June 7, 1985  
ST-HL-AE-1268  
File No.: G9.15

South Texas Project  
Units 1 & 2  
Docket Nos. STN 50-498, STN 50-499  
Revision to FSAR Questions  
Diesel Generators and Lighting Systems

List of Revised Questions

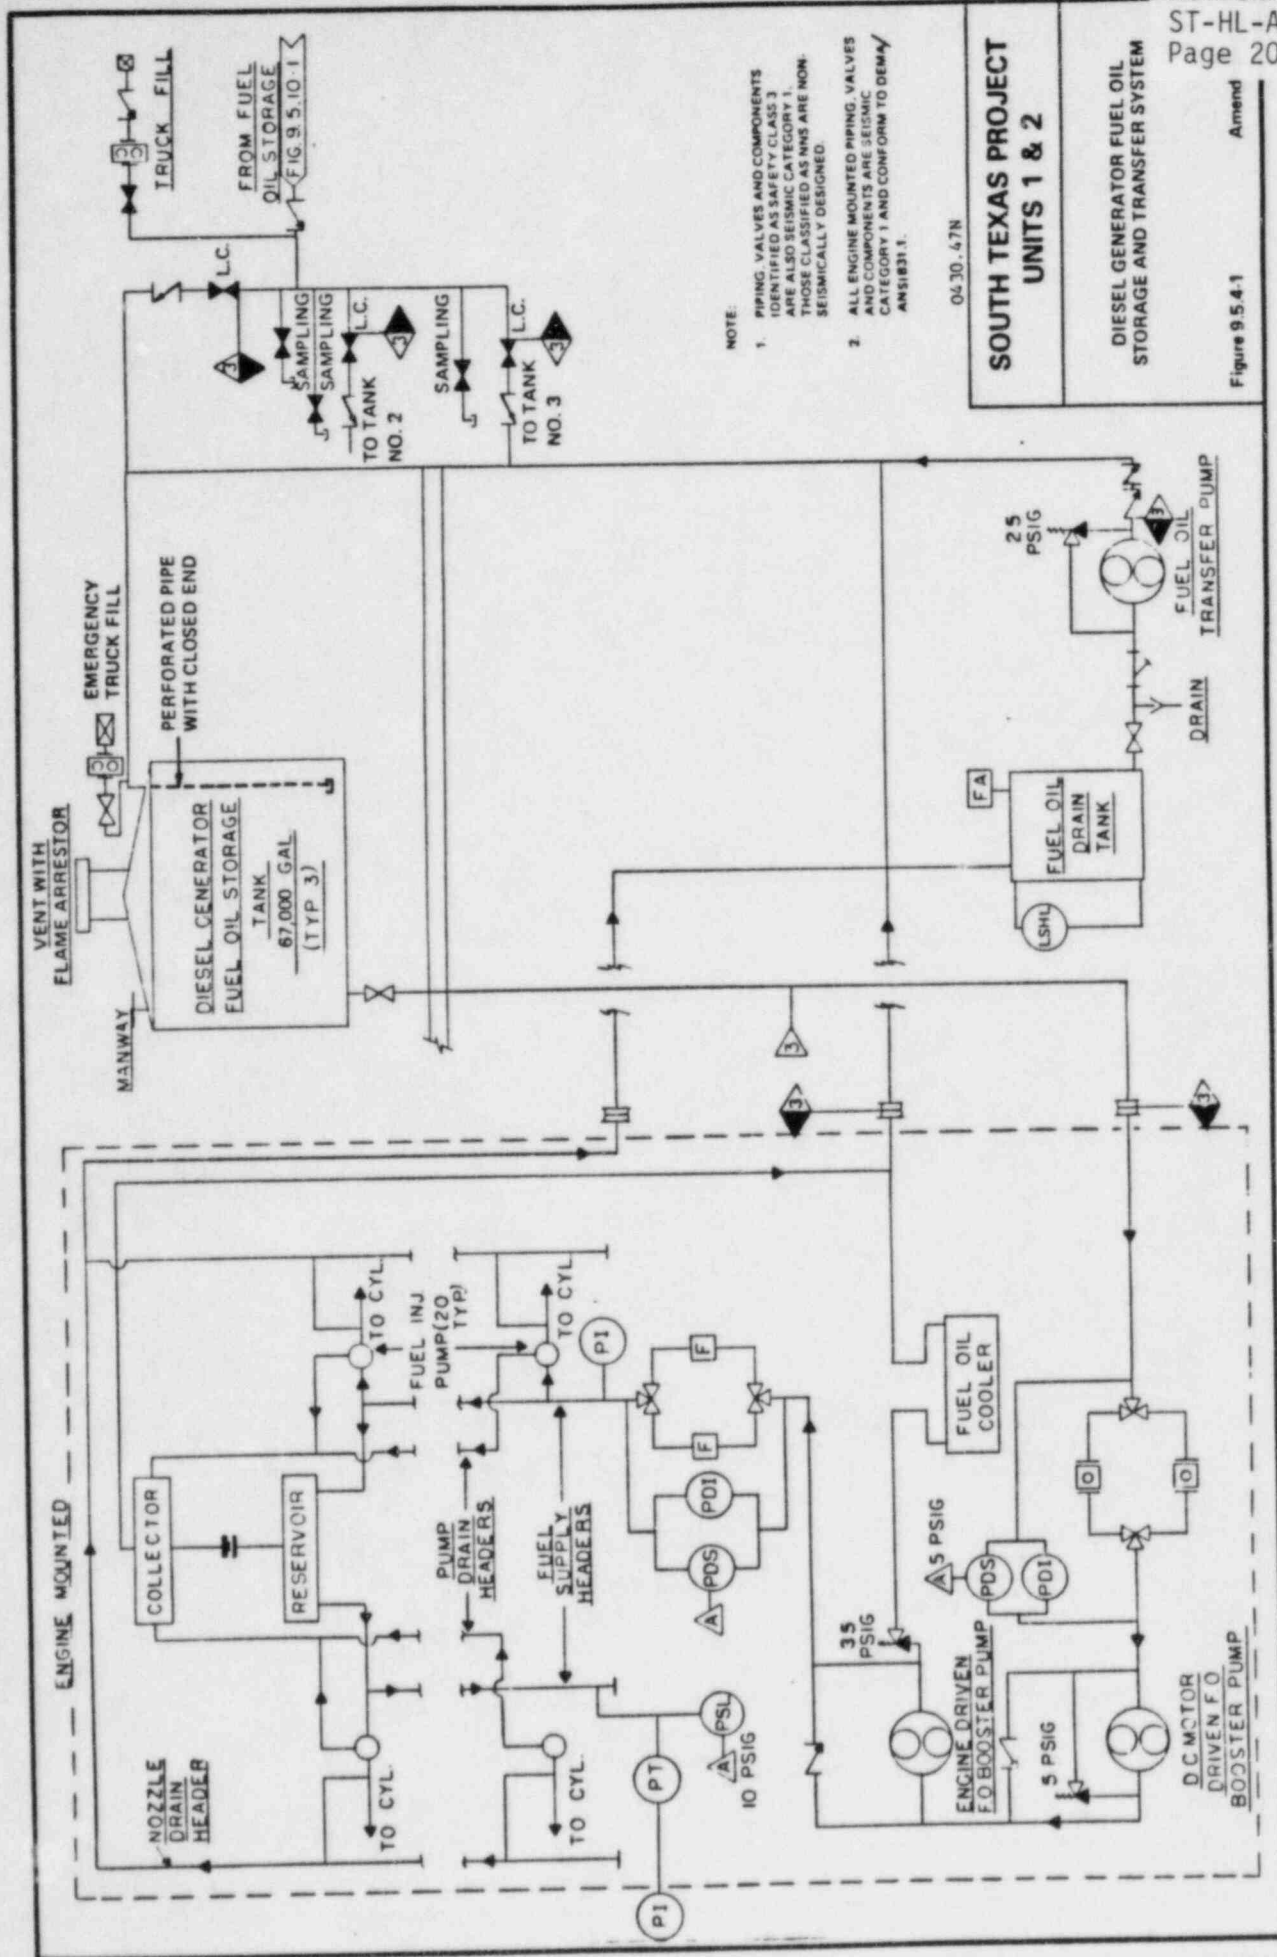
Show by analysis that a potential fire in the diesel generator building together with a single failure of the fire protection system will not degrade the quality of the diesel combustion air so that the remaining diesel will be able to provide full rated power.

1. As shown in Figure 1.2-10 the diesel exhaust is discharged to atmosphere through the north wall of the diesel generator building. Analysis results indicate an insignificant reduction in the oxygen level of the combustion air would occur as the result of predominant southerly or northerly winds directing a portion of the exhaust gases to the elevation of the air intake. This dilution would not affect engine operation. The only gaseous fire extinguishing medium for STP is halon used in the relay room, the computer room, the TSC computer room in the EAB, the Administration Building and the radwaste control room in the MAB. Release of halon from these buildings would be a controlled operation. No fire extinguishing gaseous medium is used for fire protection for the DGB.

2. From a geometrical standpoint, the combustion air intake louvers on the north side of the DGB are 90° with respect to the auxiliary ESF transformers which are approximately 20 ft east and 10 ft south of the building. The transformers are supplied with an automatic deluge system. A class B fire could result from an oil spill or internal shorts. Thirty minute response time and thirty minute fire brigade action would result in extinguishing the fire via existing fire hydrants or fire department connections with access to the deluge valve immediately adjacent to the DGB, in case of a single failure of the automatic deluge system.

3. A single failure of the fire protection system could result in the unavailability of the sprinkler system for a given engine compartment. The compartment ventilation system continues to be operational ensuring a purge of the smoke from the affected compartment. The smoke is exhausted approximately 30 ft south and 43 ft above the elevation of the combustion air intake louvers and, therefore, will tend to rise rather than be drawn down to the air intake louvers. Aspects of fire fighting are identical to those identified in 2 above. Until the closure of the thermal link dampers the smoke will be vented on the north side of the DGB via the oil room exhaust fan and duct. The exhaust gas will be hot and will rise, and as the gas rises, dilution will occur.

4. An analysis using the methods of James Halitsky in "Gas Diffusion Near Buildings" was performed (see reference 9.5.8-1). The results indicate that the following reductions would occur in the oxygen level of the combustion air intake:

DIESEL GENERATOR  
COMBUSTION AIR INTAKE  
AND EXHAUST  
FIGURE 9.5.8-1

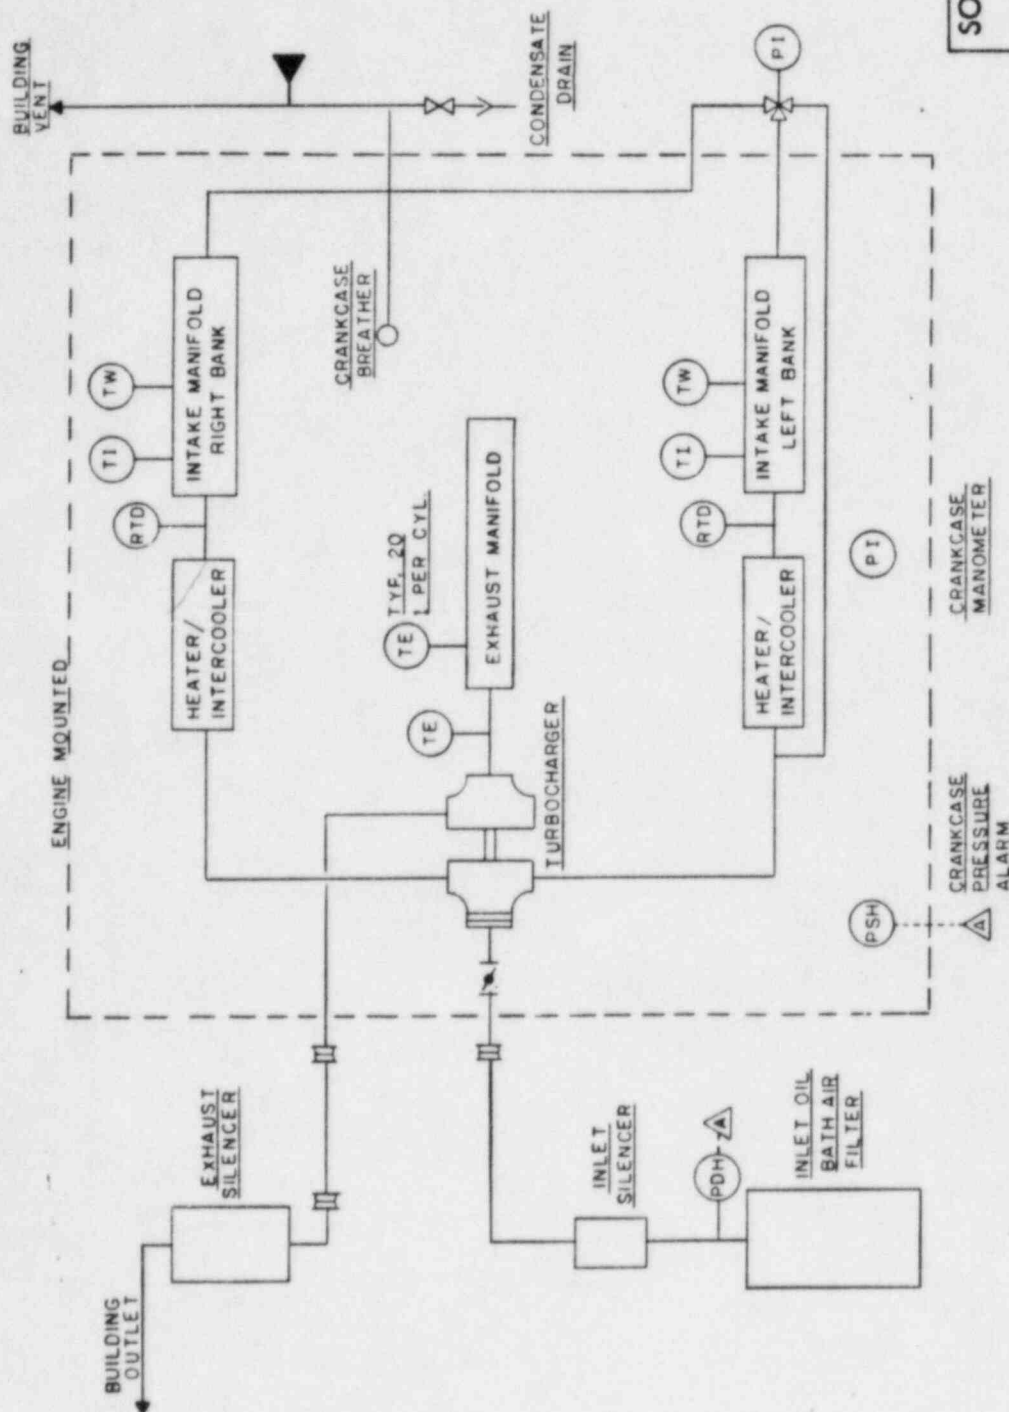
The FSAR text, Figure 9.5.4-1 through 9.5.8-1, and Table 3.2-1 states that the components and piping systems for the diesel generator auxiliaries (fuel oil system, cooling water, lubrication, air starting, and intake and combustion system) that are mounted on the auxiliary skids are designed seismic Category I and are ASME Section III Class 3 quality. The engine mounted components and piping are designed and manufactured to DEMA standards, and are seismic Category I. This is not in accordance with Regulatory Guide 1.26 which requires the entire diesel generator auxiliary systems be designed to ASME Section III Class 3 or Quality Group C. Provide the industry standards that were used in the design, manufacture, and inspection of the engine mounted piping and components. Also show on the appropriate P & ID's where the Quality Group Classification changes from ASME Section III Class 3 (Quality Group C).

The engine mounted components and piping for the diesel generator's auxiliaries are considered part of the engine; their design and function are integrated with the engine rather than the skid piping. Therefore, they are designed and manufactured to standards applicable to the engine (DEMA) and are seismic Category I. It is noted that the engine mounted piping is manufactured to ANSI B31.1 standards. The DEMA standards provide assurance that these auxiliaries are designed, fabricated, erected, and tested to quality standards commensurate with the safety function to be performed. In addition to DEMA tests, the engine is qualified by a reliability test.

Amended Figures 9.5.5-1, 9.5.7-1, and 9.5.4-1, 9.5.6-1, and 9.5.8-1 show quality group changes.
